RE: Crescent Hydroelectric Project (P-4678) and
Vischer Ferry Hydroelectric Project (P-4679)
Response to Additional Information Request (AIR), Dated August 7, 2023

SCHEDULE A - Responses to FERC August 7, 2023 AIR

Response to AIR Item #2

RE: Vischer Ferry Dam Modification Project
Response to FERC's August AIR Letter

Figure 1: Project Discharge Rating Curve during Non-Navigation Season

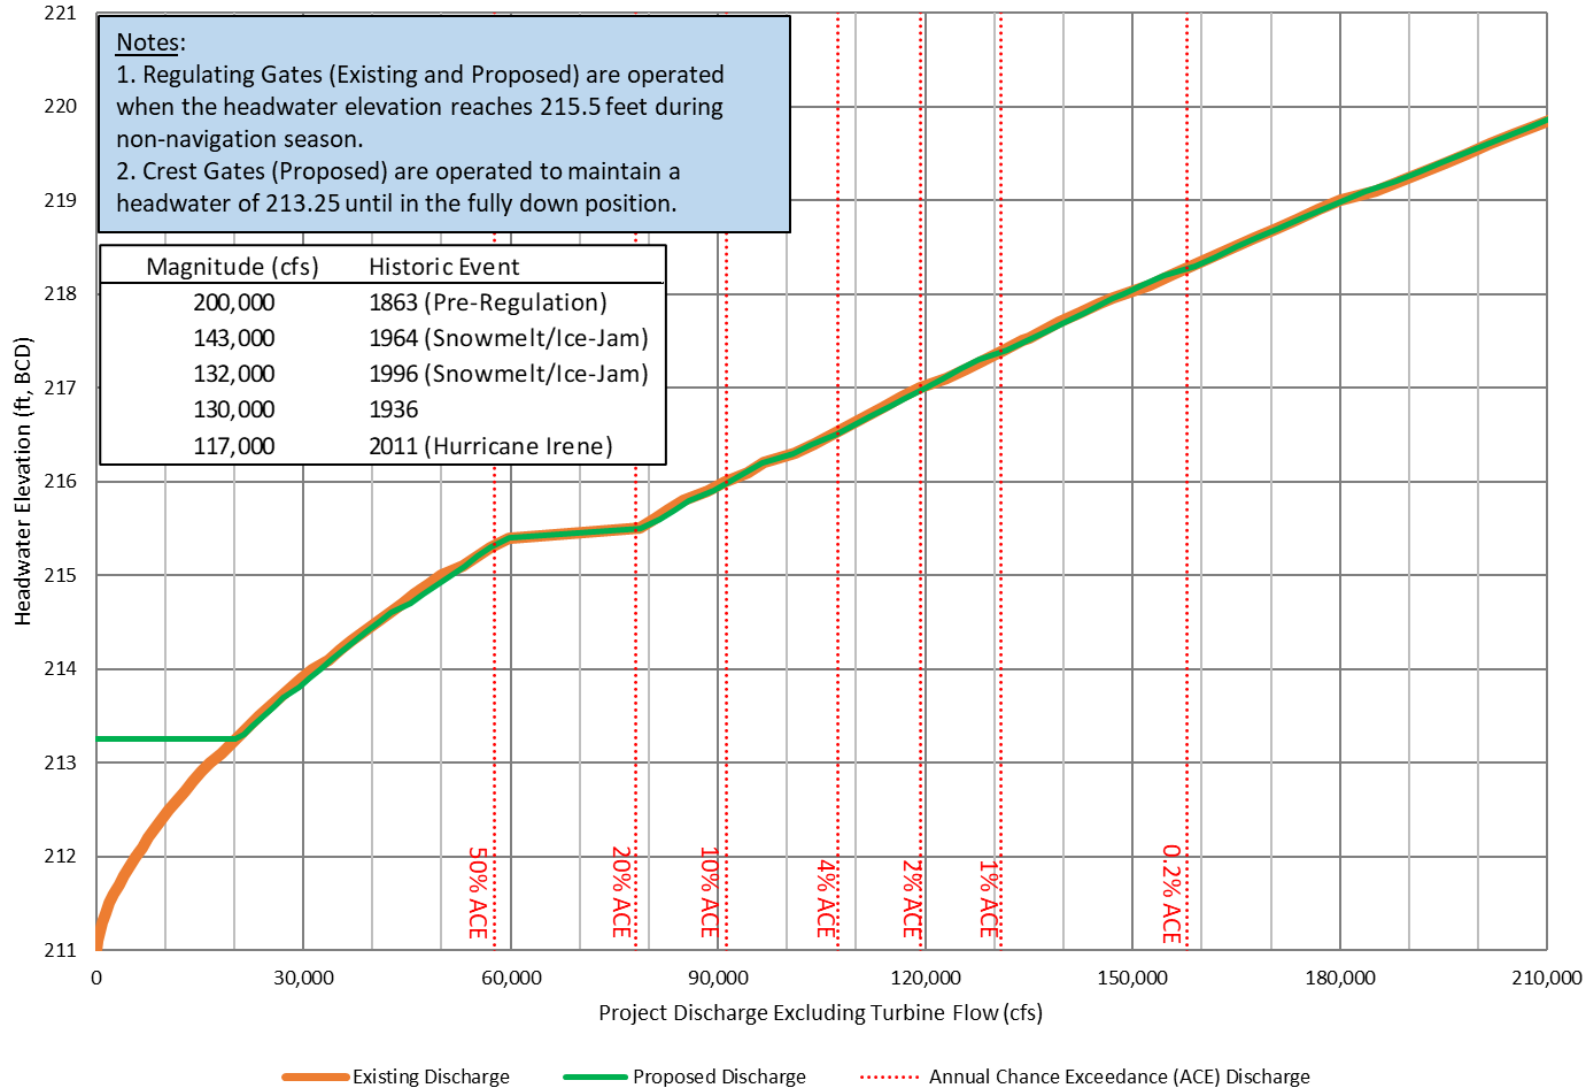
FERC Item 2: *It is unclear what NYPA's proposed changes to the operation of the Vischer Ferry Project and its features would have on upstream and downstream flooding of non-project properties and structures. The proposed modifications would entail replacing the existing 27-inch flashboards with 27-inch pneumatically actuated crest gates (crest gates) on dams D and E, and a combination of 27-inch and 48-inch crest gates on dam F. The installation of 48-inch crest gates would require that the crest of dam F be lowered by 21 inches. Furthermore, as discussed above in item 1, the proposed changes would result in higher impoundment elevations relative to existing conditions, as the impoundment would be maintained at an elevation of 213.25 feet on a year-round basis—not just during the navigation season (May through October). Therefore, please prepare an engineering analysis that includes:*

- c. *A comparison of how potential flood impacts in areas upstream and downstream of the project would differ for each historical and flood frequency event. The comparison should quantify the number of flooded non-project properties and structures, the depth and velocity of water at these structures, and the total inundated area. This analysis will likely require using a hydraulic model, as suggested in item (a) above, to route flows for the various events. If any non-project properties and structures are flooded as a result of the proposed modifications, the affected features should be evaluated to determine whether they can withstand collapsing or being washed away. Resources such as the U.S. Bureau of Reclamation ACER Technical Memorandum No. 11, Reclamation Consequence Estimating Methodology (RCEM), and/or U.S. Army Corps of Engineers' LifeSim software may facilitate this evaluation;*

Stage-discharge computations were obtained for Dams D, E, and F under both existing and proposed conditions (Kleinschmidt Associates, 2023). For the proposed conditions, the rating curve considers the reduction in spillway length due to the introduction of piers between crest gate sections. Discharge over each dam was computed using the weir equation. The weir discharge coefficient for Dams D and F was based on guidance in “The Design of Small Dams” (United States Bureau of Reclamation, 1987) regarding ogee shaped spillways. The weir discharge coefficient for Dam E was based on guidance in “Handbook of Hydraulics” (Brater and King, 1976) regarding broad crested weirs. The head on each weir considered both potential and velocity head. Submergence effects were considered but did not apply to the range of flows computed in this study. The design proceeded such that the proposed spillway capacity with the crest gates in the lowered position closely matches the existing spillway capacity when the flashboards are removed. Stage-discharge computation for other Project structures (e.g., Regulating Gates, Embankment, Lock Wall, Sluice Gates) were obtained from the study used to develop the stage-discharge curves presented in the Project’s Supporting Technical Information Document (STID). The stage-discharge rating curves for these structures were added to the stage-discharge curves for Dams D, E, and F to develop existing and proposed Project stage-discharge rating curves. The proposed Project stage-discharge rating curve was modified to indicate operation of the crest gates to maintain a headwater elevation of approximately 213.25 feet, Barge Canal Datum (BCD). A comparison of the existing and proposed Project discharge rating curves is provided in Figure 1.

The proposed changes in operation of the Project will produce higher normal impoundment elevations during the non-navigation season relative to existing conditions under flows less than approximately 20,000 cfs. This is due to the plan to operate the proposed crest gates in the “up” position to maintain the navigation season normal pool year-round, whereas currently flashboards that maintain navigation season normal pool are removed during the non-navigation season. However, due to the design of the crest modifications and proposed operating procedures of the crest gates, there is little change to the discharge capacity of the Project under any substantial flood scenario. As such, higher impoundment elevations during the non-navigation season are limited to times when the total river flow is less than half the magnitude of the 50% Annual Chance Exceedance (ACE) event (i.e., 2-year recurrence interval). In conclusion, the proposed changes in operation of the Project will have no substantive impact on upstream and downstream flooding of non-project properties and structures, a more detailed analysis of flood impacts on individual structures is not required, and no modifications or remedial measures are necessary to mitigate upstream or downstream flooding impacts.

Figure 1. Calibrated ice thickness variation of 2021-22 winter by freezing degree-day method. (Figure 7 of the Report).

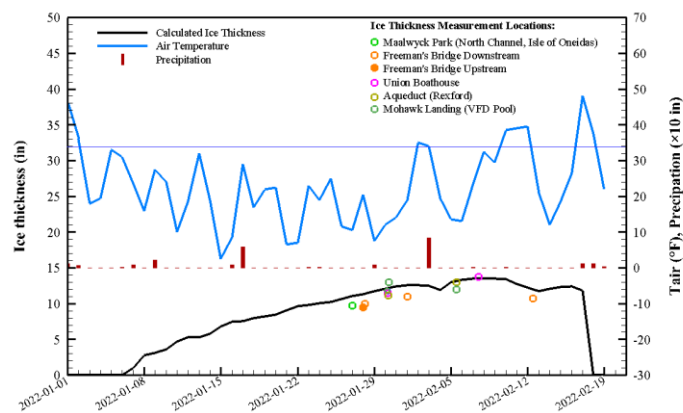
Item 5: Section 2.1 of the "Effect of Vischer Ferry Dam Modification Alternatives on Ice Jam Flooding" report filed on July 10, 2023, describes the determination of ice cover thickness using the freezing degree-day method that was calibrated with the 2022 field data (air temperature, precipitation, etc.). The thickness of ice fragments in the ice breaking channel was calculated to be 0.08 meter (3 inches) with periodic ice breaking in the channel during the winter. Was the thickness of ice fragments (i.e., 0.08 meter) calculated for 2022 and then used for the 2018 ice-jam modeling scenarios or was it predicted for the 2018 ice-jam event (i.e., using 2018 air temperature data) using the calibrated freezing degree-day method and then used for the 2018 ice-jam modeling scenarios? Please explain.

As stated in Section 2.1 of the Report, the freezing-degree-day (FDD) method was calibrated with the field data obtained in 2022, as shown in Figure 1 below (Fig. 7 of the Report). This calibrated model was then used to calculate the ice fragment thickness in the ice-breaking channel, as shown in Fig. 2 below. Based on the calculated ice thickness using this model, Figure 2 below shows that for any two days of the 2018 winter season, the theoretical ice thickness would be
